Department of Transportation & Public Facilities Division of Supply & Services 2200 E. 42<sup>nd</sup> Avenue Anchorage, AK 99508

# ITB TITLE: Snow Plow & Sanding - TSAIA Parking Lots - Amendment One (1)

**THIS AMENDMENT SERVES TO:** Answer questions from potential bidders and add language to the ITB; related to "Continous Snow Removal" (CSR).

# MAPS, ANC Parking Lot Areas in Need of Service Page 2 of 2 (Revised 7-21-23)

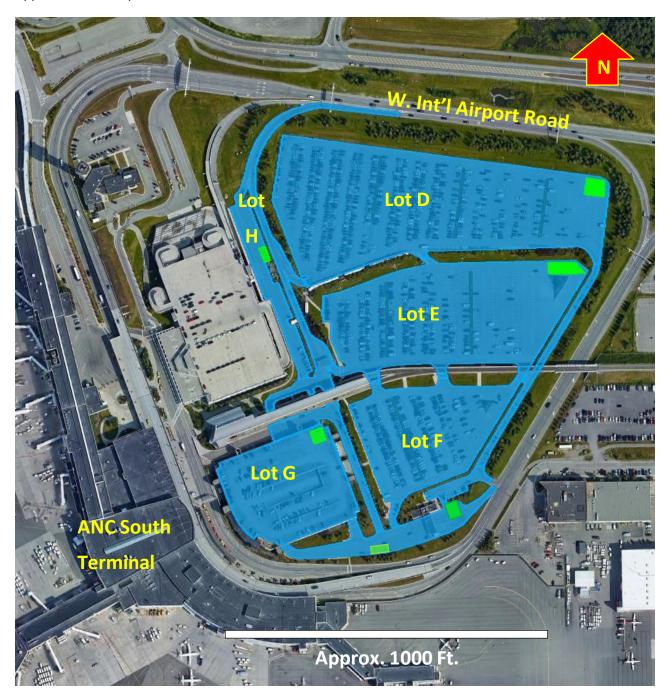
- 35. QUESTION: "Will there be updated maps showing where to stack snow piles?" ANSWER: Yes. see attached. Note: If ANC determines increased efficiency will be achieved by altering the location/number of snow piles, the locations indicated on the attachment are subject to change.
